CITY PLAN COMMISSION STAFF REPORT

Falk Quarry

CD-CPC-2024-00152

The applicant is seeking approval of a major amendment to an approved development plan to incorporate new phasing and building layout, in District M2-2 (Manufacturing) to allow for the existing land reclamation, quarry, excavation, office, commercial and warehouse development.

DEVELOPMENT PLAN
Development Plan for:
QUARRY YARD DEVELOPMENT
Kansas City, Jackson County, Missouri

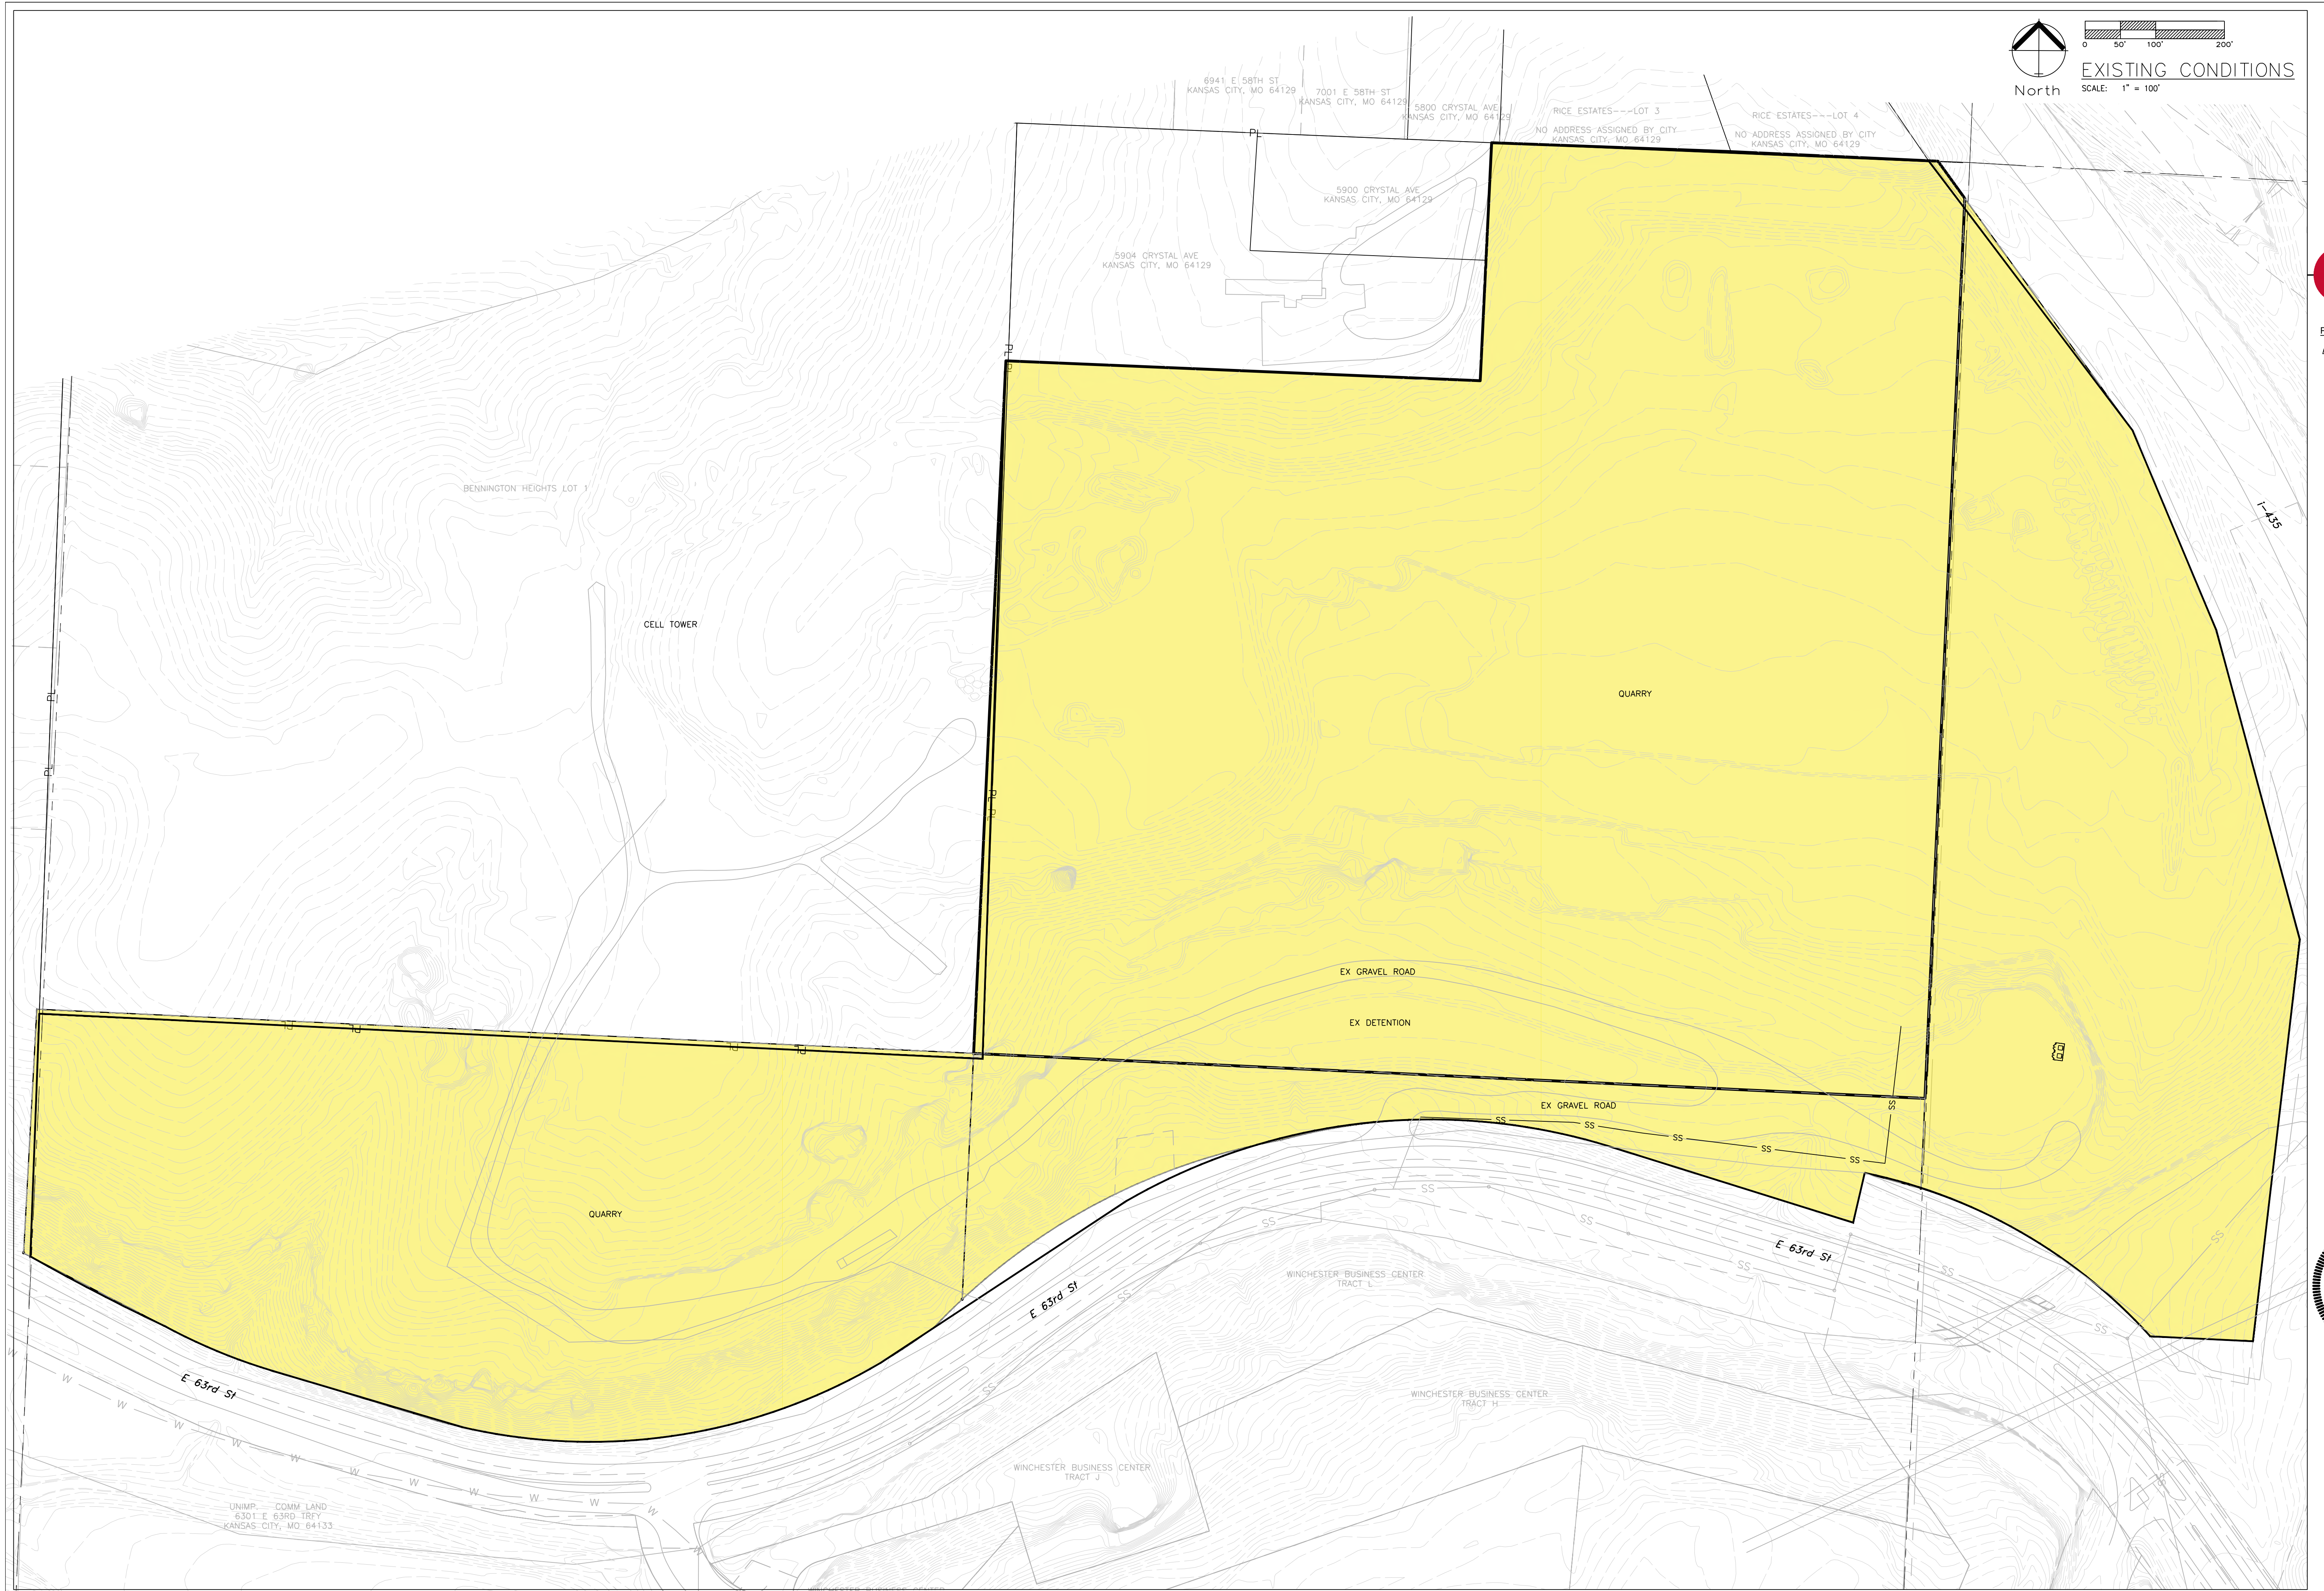
Access to the development will be provided via the existing driveway on the north side of E. 63rd Traffic Way. The plan does not show pedestrian connectivity to the public right of way from the proposed office building. Staff recommends the plan be revised to show a safe pedestrian connection to E. 63rd Street.

- D. The plan must provide for safe, efficient, and convenient non-motorized travel opportunities, being pedestrian and bicycle movement, on the subject site;**
The proposed plan does not show on site pedestrian circulation connecting to the public right of way. Staff recommend as sidewalk be shown on the plan. (OA)

Landscape Plan
Development Plan for:
FALK QUARRY
Kansas City, Jackson County, Missouri

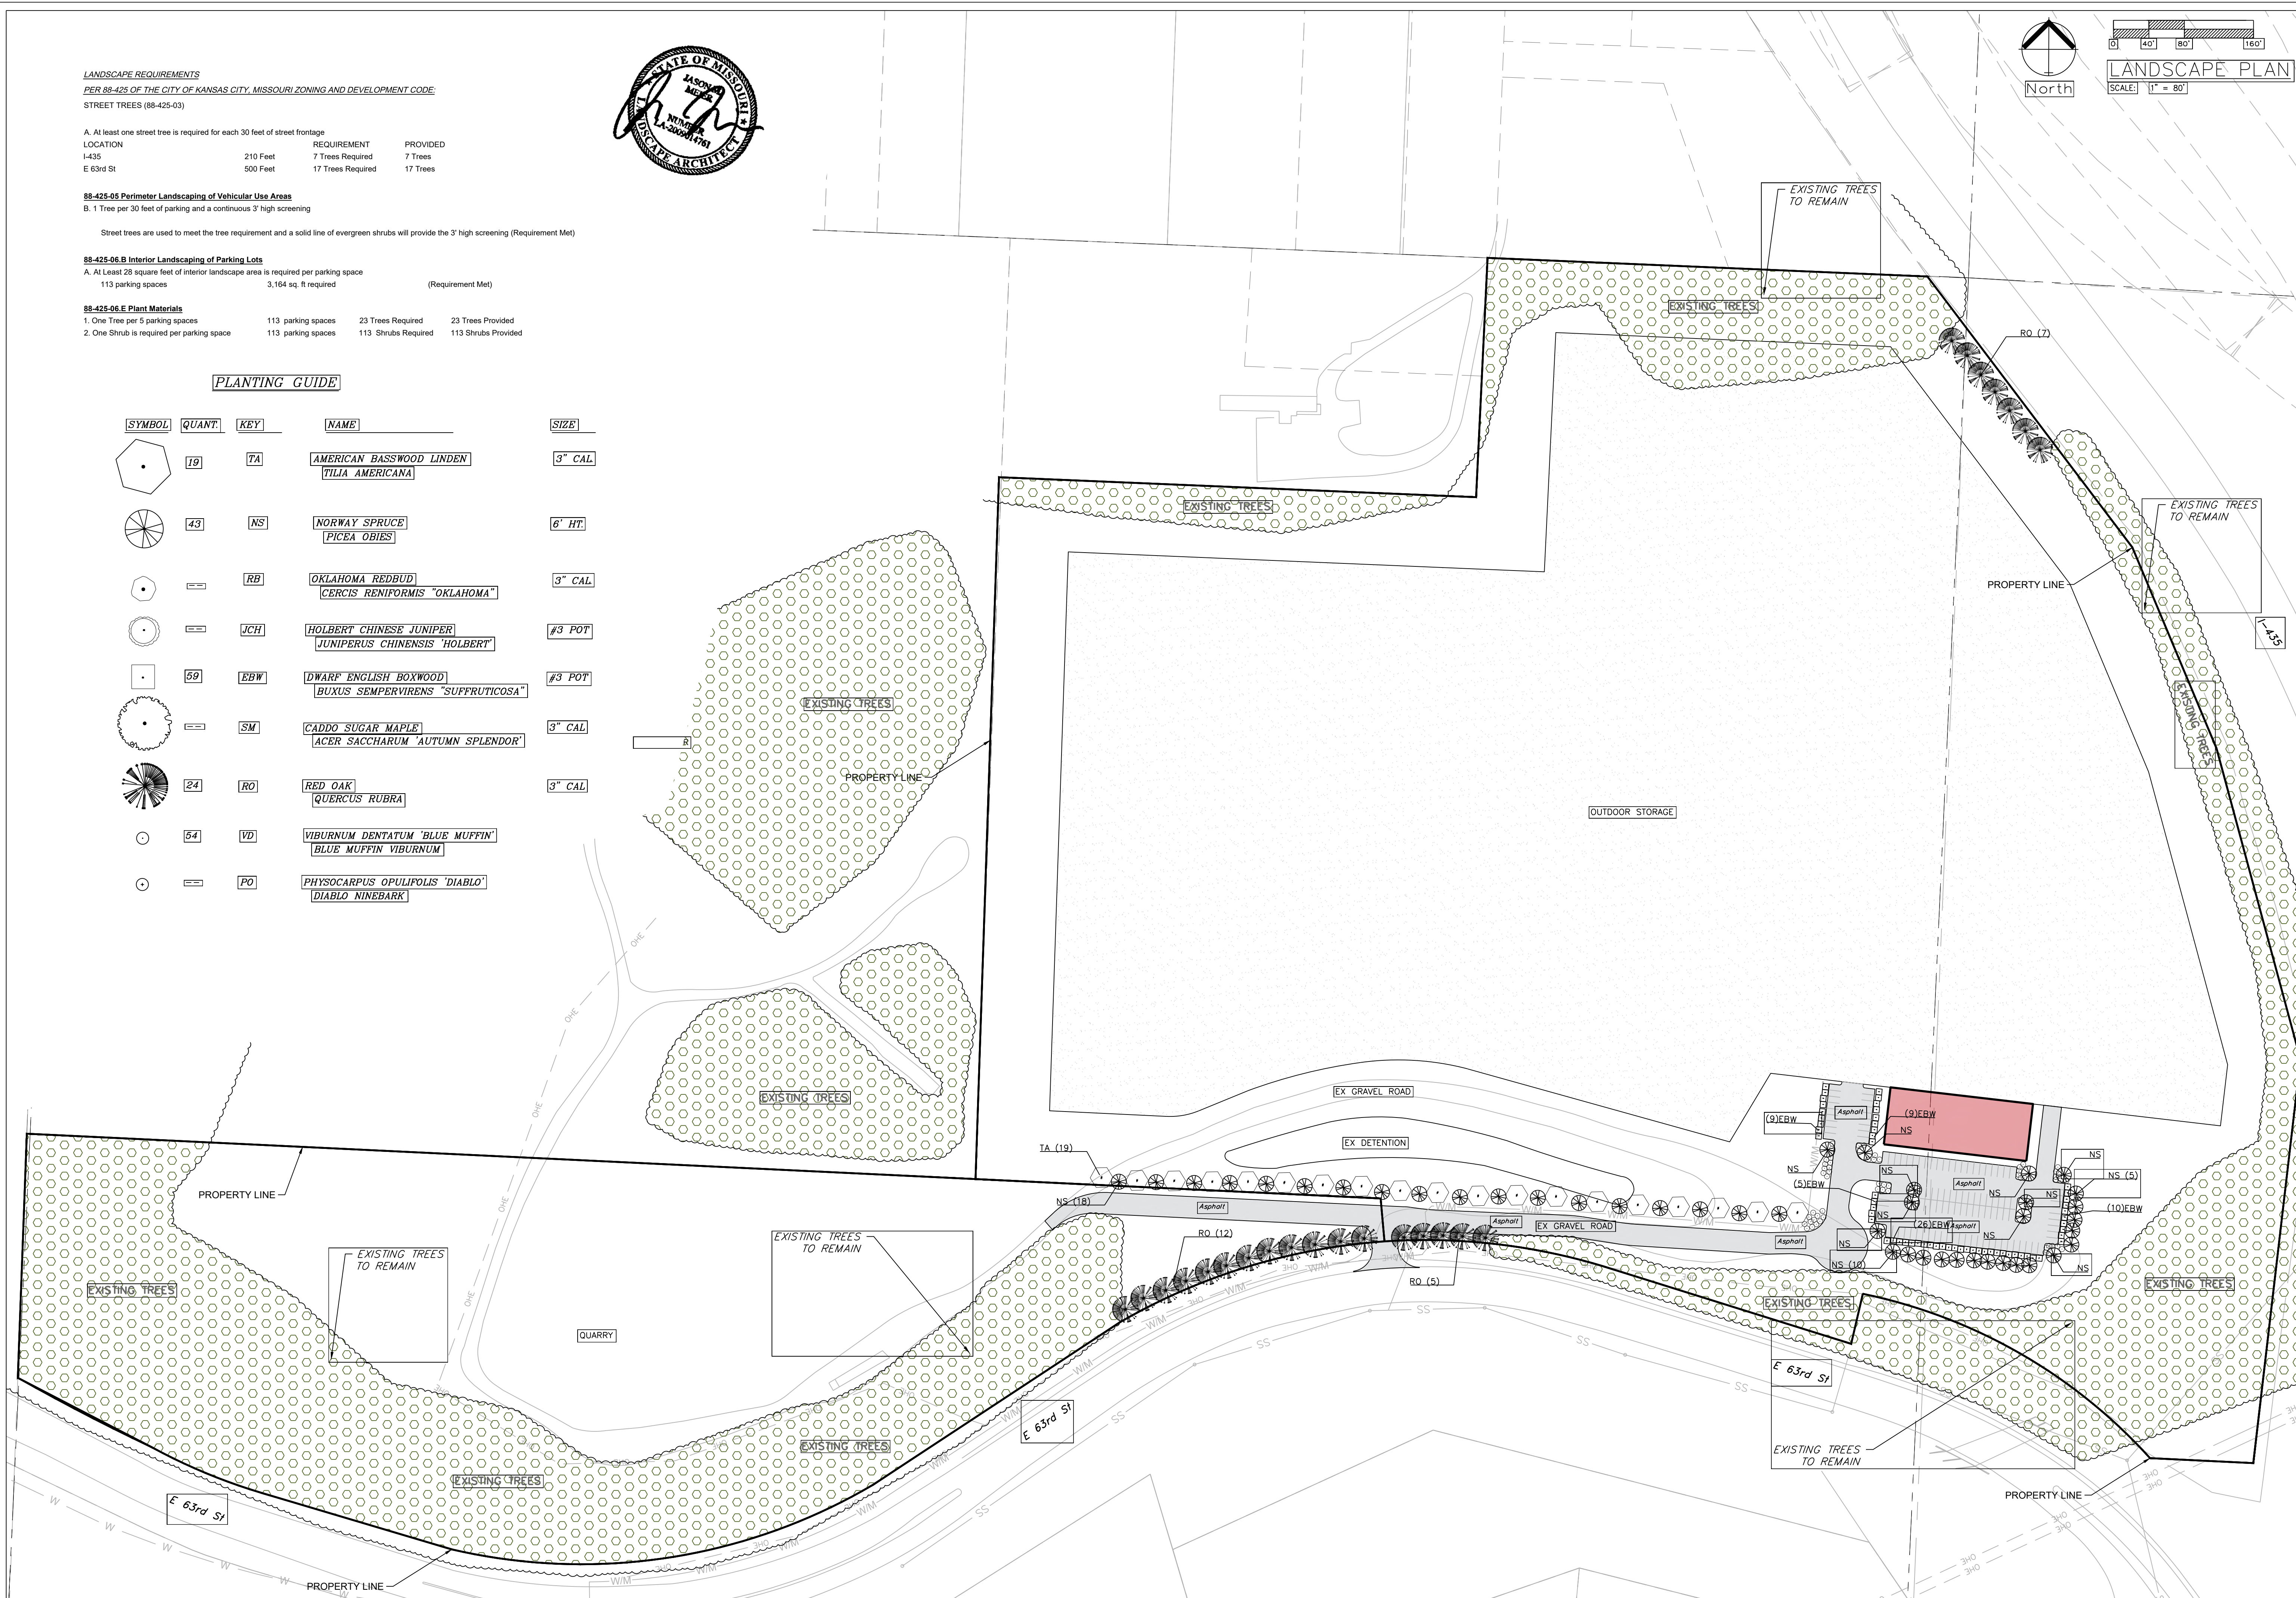
The site sits below the existing residences to the north and above E. 63rd Traffic Way on the south. The applicant has provided a landscaping plan that focuses landscaping elements along the public roadway frontages. (OA)
